Seismic Evaluation Guidance

*Screening, Prioritization and
Implementation Details (SPID) for the
Resolution of Fukushima Near-Term Task
Force Recommendation 2.1: Seismic*

Draft Report, October 2012

Figure 1-1
 Recommended Approach to Respond to Information Request 2.1

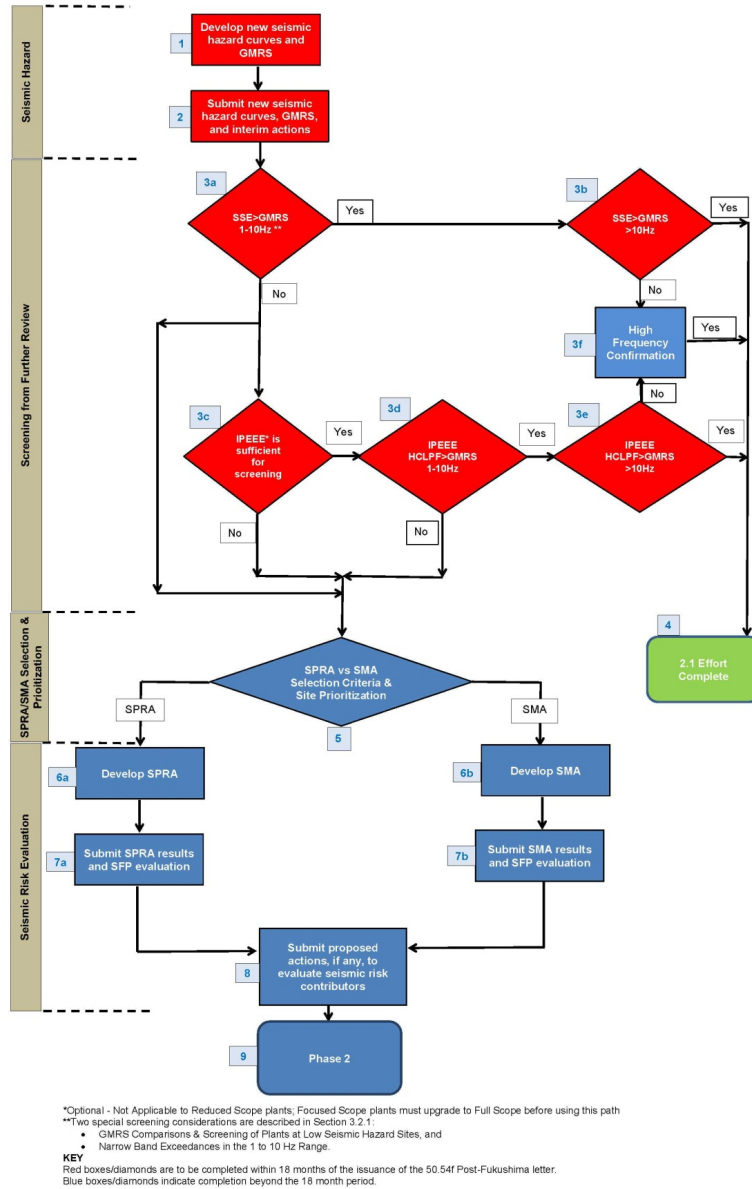
Comment [C3]: Consistency with Section 6.6? Highlighted portion limits applicability of SPID Guidance.

Comment [GSH4]: Should not limit applicability. Need careful wording in Section 6.6 to ensure not limiting.

Figure 7-1
Basic Process for Evaluation of Potential Failures for Penetrations below Top of Irradiated Fuel

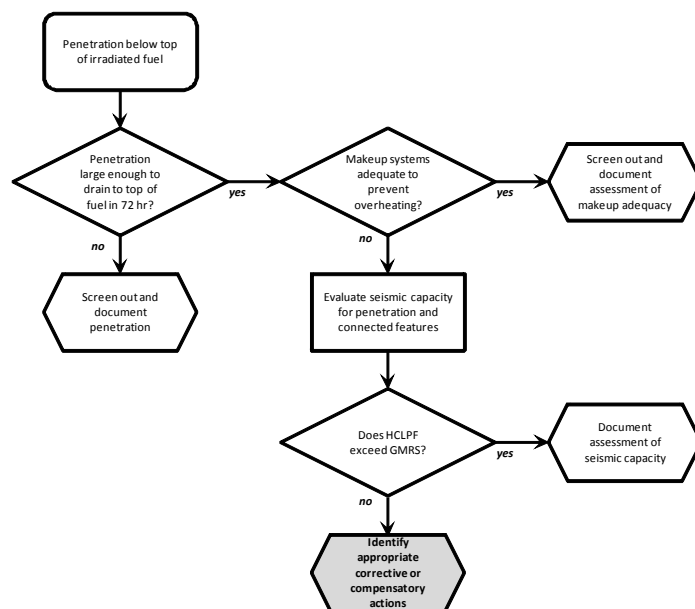
Comment [E24]: Change bottom outcome to PHASE2

Figure 7-2
Basic Process for Evaluation of Potential Failures for Penetrations above Top of Irradiated Fuel

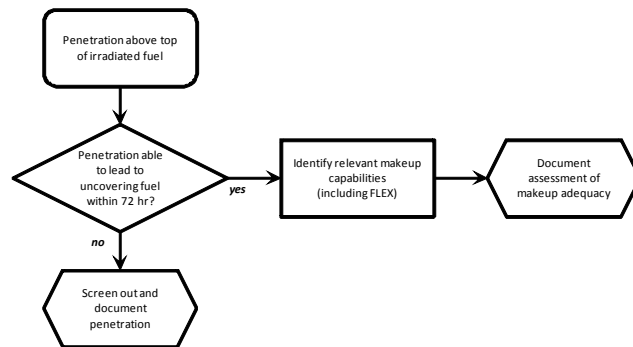
Comment [E27]: Consider whether should follow Figure 7-1 logic
